## MEMORANDUM

**REVIEW TYPE:** Site Plan Review  
**APPLYING FOR:** RNC Zone; 70.50 Acres Property  
 32 One-Family Dwelling Units/Lots  
**PROJECT NAME:** Meadowsweet (Farquhar Property)  
**CASE #:** 8-04004  
**REVIEW BASIS:** Site Plan Review Required in the RNC Zone, Article 59-D  
 Site Plan Review Required for reduced width tertiary street,  
 Subd. Rgl. 50-26(h)

# EQUESTRIAN TRAIL MAP

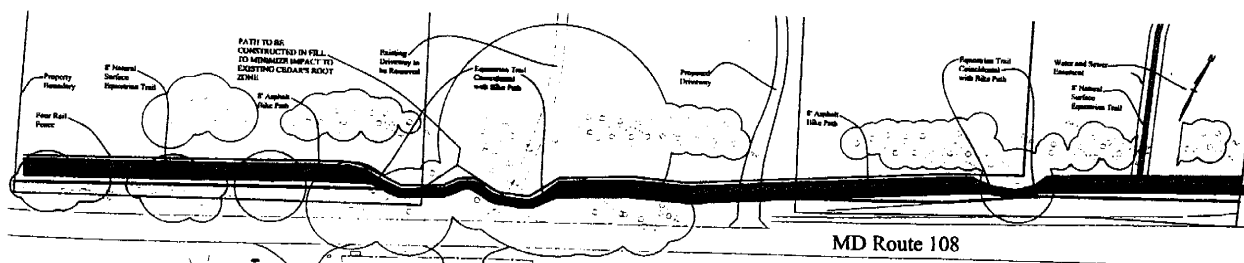
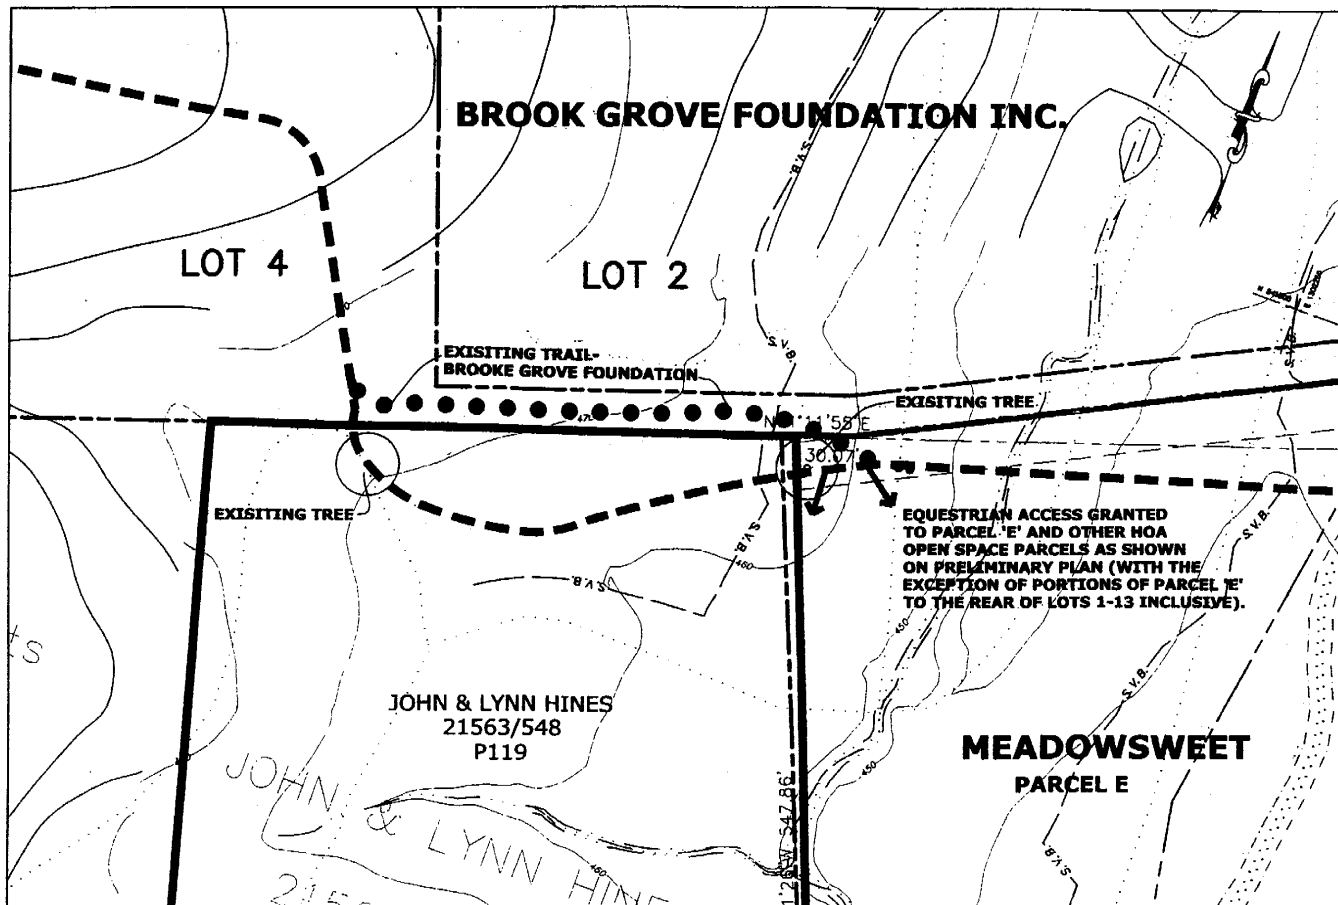
The location of the east-west connection from Brooke Road to Marden Lane is the primary connection sought by the equestrian community, although the existing alignment traverses north through Brook Grove to Dr. Mess' property (See attached map on next page for location of properties and existing trails). During the hearing the equestrian community testified that an easement through the subject property would be more desirable because it provides a clear connection to Marden Lane without having to encroach onto Brooke Grove property. In lieu-of the fact that all points lead north through Brook Grove, the equestrian community has decided that the alignment north of Parcel 119, which closely follows the existing trail, is preferable. Mr. Hines (Parcel 119) has offered a letter of support (Appendix D) for the equestrian riders to access his property with the condition that an easement would not be provided on his property. The existing trail leads to the southern boundary of the Brook Grove property containing a portion of Marden Lane that was abandoned by County Council Resolution No. 13-914. The equestrian community realizes that public easements have not been obtained through the Brook Grove property but feels optimistic that continued use of the existing trails and a longstanding relationship with the Brook Grove Foundation will be permitted.

Staff supports the location of the proposed equestrian and pedestrian easements but contends that the future alignment and access will always be through Brooke Grove property to the Mess property, regardless of whether the equestrian trail connects to Marden Lane north of Parcel 119 or to the south through the subject property. Equestrians will have designated easements from Brooke Road to MD 108, through the subject property, providing a future link to the Rural Legacy Trail south of MD 108. The easement also provides access along the northern property line to Parcel 119, connecting to an existing equestrian trail presently used by the equestrian community.

**Meadowsweet Property:**  
Proposed Location of  
8' Asphalt Bike Path

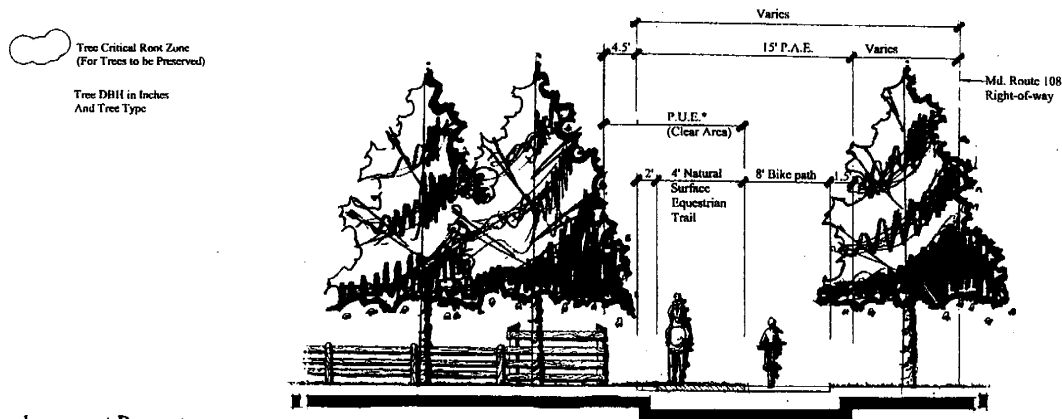
- c. Provide an 8-foot-wide Class I bikeway and 4-foot-wide natural surface equestrian trail from the eastern boundary of Parcel 587 to the western driveway of Sherwood Elementary School, on the north side of MD 108.

- e. Provide a continuous eight-foot-wide Class I bikeway along the north side of MD 108 (and across parcel 444) between Sherwood Elementary School/eastern property line and the western property line at parcel 587.
